Response to Referral Advice - Application ID 24029819 at 162 - 168 Gouger Street, Adelaide

MasterPlan act for the applicant, Square Mile Properties Pty Ltd, in respect of Development Application ID 24029819 for the construction of a mixed-use building up to 16 levels in height, comprised of 107 dwellings with podium car parking and three ground level shops at 162 – 168 Gouger Street, Adelaide.

PROPOSED MIXED USE DEVELOPMENT – 162 GOUGER STREET, ADELAIDE – RESPONSE TO REQUEST FOR INFORMATION (TRAFFIC ACCESS AND PARKING)

Figure A: AM and PM peak hour traffic counts - Wednesday 27 November 2024

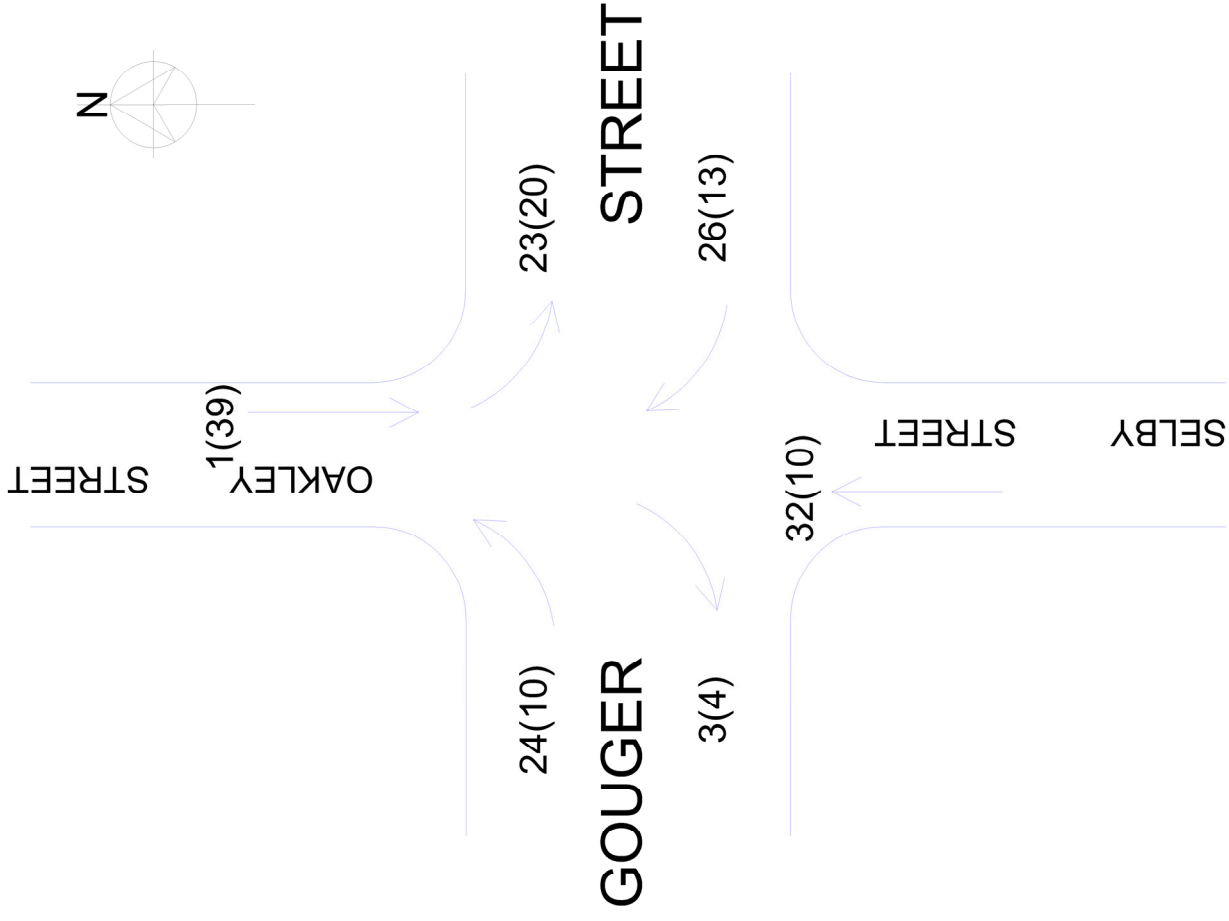
An assessment of the net traffic impact should be undertaken to the intersections of Oakley/Gouger Streets and Oakley/Grote Streets.

The results of the surveys at the above intersection identified that the peak hourly traffic flows occurred between:

- 8.15 am and 9.15 am, and
- 4.15 pm and 5.15 pm.

It was identified that in the morning peak hour period at the above intersection there was a total of 82 vehicles entering Oakley Street from Selby Street and Gouger Street and a total of 27 vehicles exiting Oakley Street turning onto either Gouger Street or crossing to Selby Street during this period.

It was identified that in the evening peak hour period at the above intersection there was a total of 33 vehicles entering Oakley Street from Selby Street and Gouger Street and a total of 63 vehicles exiting Oakley Street turning onto either Gouger Street or crossing to Selby Street during this period.

The above recorded am and pm peak hour traffic volumes are summarised in *Figure A* included as an attachment to this document.
